OYSTER CREEK NUCLEAR GENERATING STATION, UNIT NO. 1

AMENDMENT TO PROVISIONAL OPERATING LICENSE

Amendment No. 42  
License No. DPR-16

SUPPORTING AMENDMENT NO. 42 TO PROVISIONAL OPERATING LICENSE NO. DPR-16

Figure 3.3.1

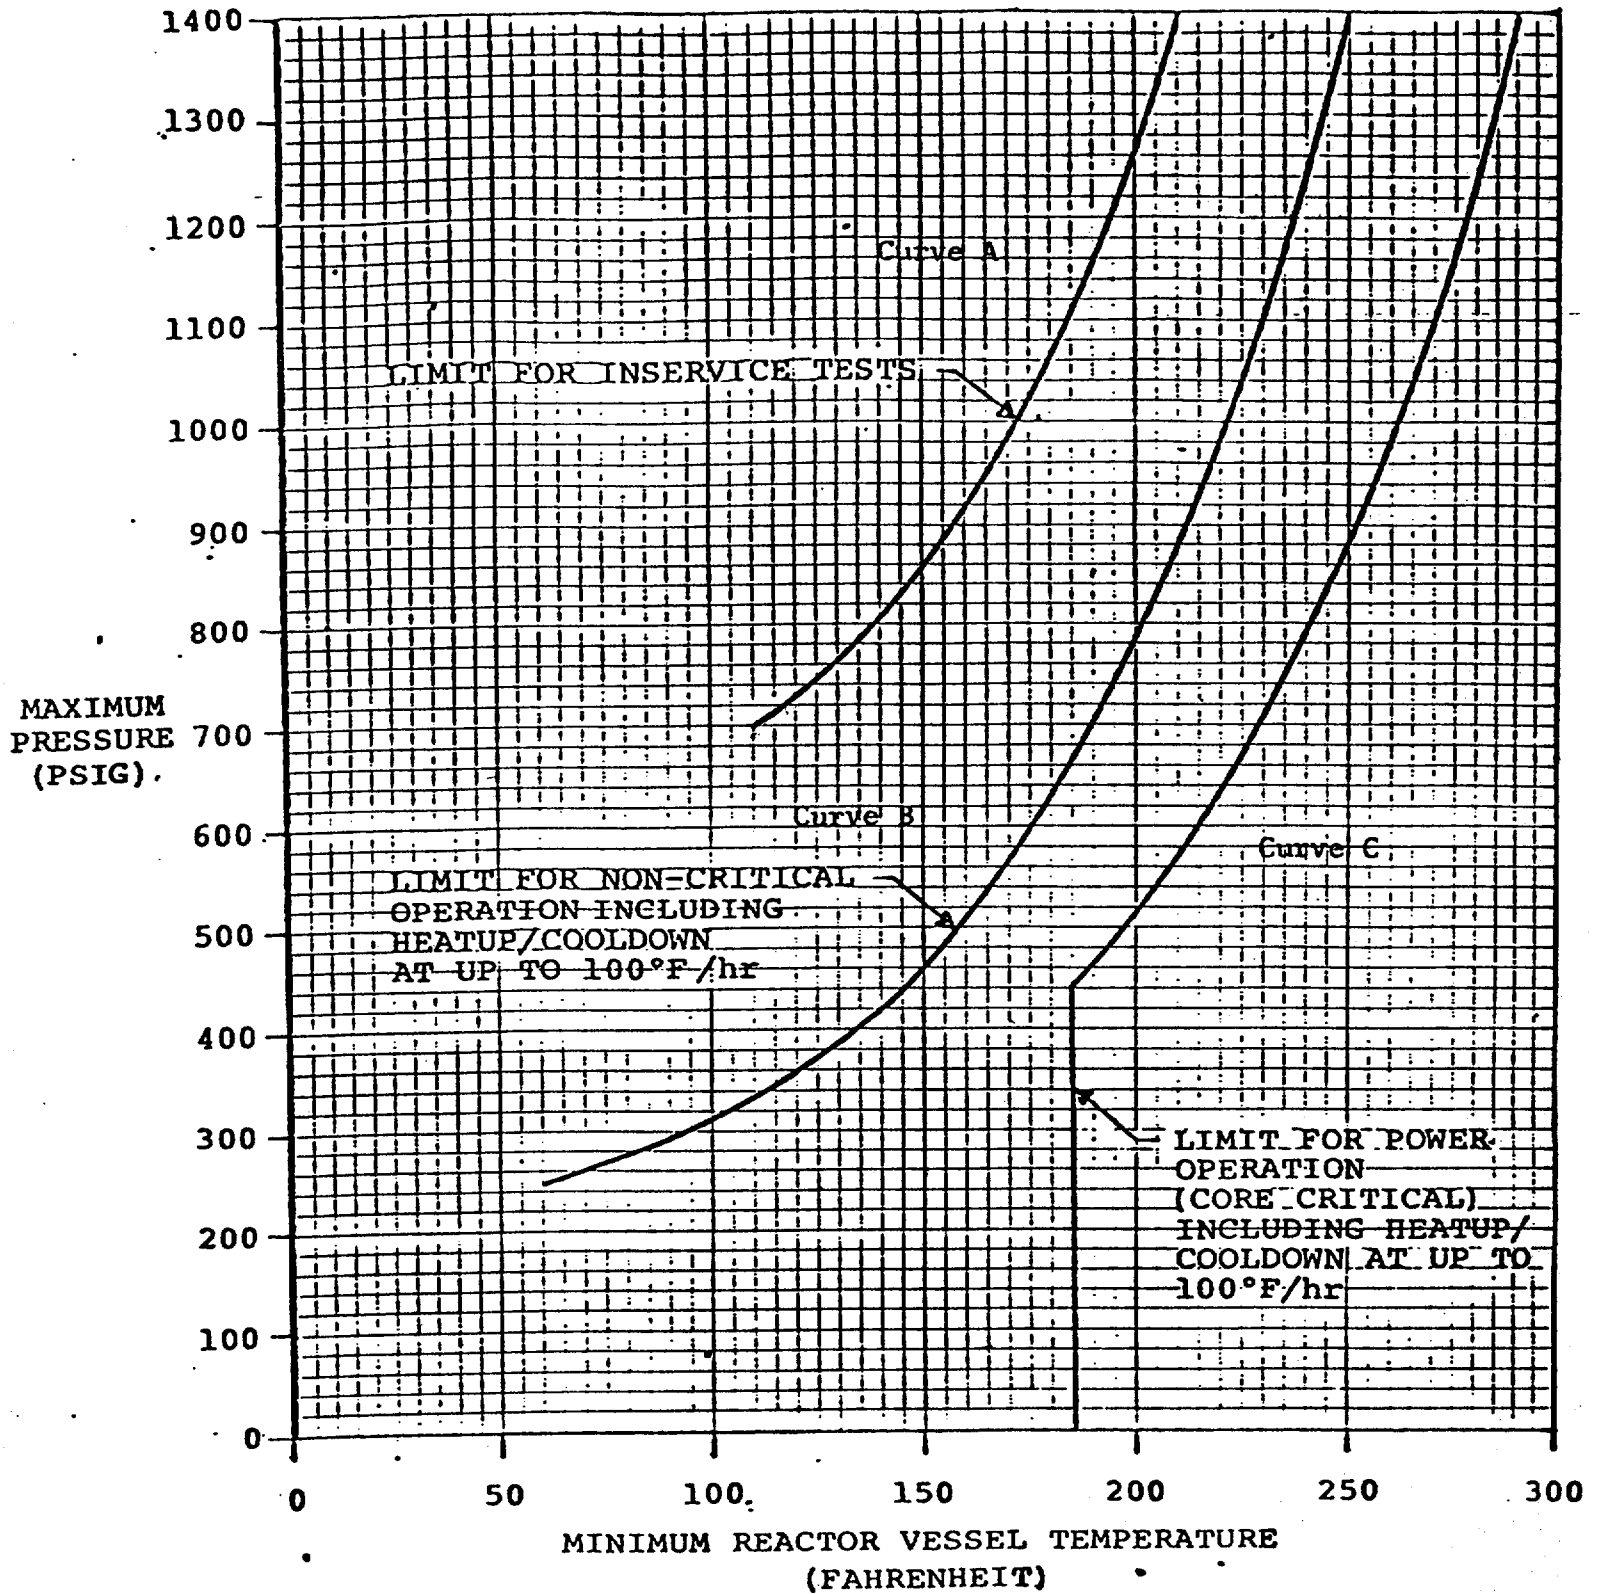
- (i) Hydrostatic Leakage Tests - the minimum reactor vessel temperature for hydrostatic leakage tests at a given pressure shall be in excess of that indicated by Curve A of Figure 3.3.1.
- (ii) Heatup and Cooldown Operations: Reactor non-critical--the minimum reactor vessel temperature for heatup and cooldown operations at a given pressure when the reactor is not critical shall be in excess of that indicated by Curve B of Figure 3.3.1.
- (iii) Power operations--The minimum reactor vessel temperature for power operations at a given pressure shall be in excess of that indicated by Curve C of Figure 3.3.1.
- (iv) Appropriate new pressure temperature limits must be approved as part of this Technical Specification when the reactor system has reached ten effective full power years of reactor operation.

Figure 3.3.1 is derived from an evaluation of the fracture toughness properties performed for Oyster Creek. (Reference 12) in an effort to establish new operating limits. The results of neutron flux dosimeter analyses in Reference 12 indicate that the total fast neutron fluence (>1 Mev) expected for Oyster Creek at the end of ten effective full power years of operation is  $1.22 \times 10^{18}$  nvt on the inside surface of the reactor vessel core region shell. A conservative fast neutron fluence of 75% of this value is assumed at the 1/4 T (one quarter of wall thickness) location for the preparation of the pressure/temperature curves in Figure 3.3.1.

We have reviewed the proposed changes to Sections 3.3.A, 3.3.B, the bases, references and the proposed pressure-temperature operating limits for Oyster Creek and have performed independent calculations to verify compliance with Appendix G. We conclude that the proposed operating limits are in accordance with Appendix G, 10 CFR Part 50 for operation through 10 EFPY and are therefore acceptable for this operating period. Conformance with Appendix G to 10 CFR Part 50 in establishing safety operating limitations will ensure adequate safety margins during operation, testing, maintenance and postulated accident conditions and constitutes an acceptable basis for satisfying the requirements to NRC General Design Criterion 31, Appendix A, 10 CFR Part 50. We, therefore, find the proposed amendment to the Technical Specifications acceptable.
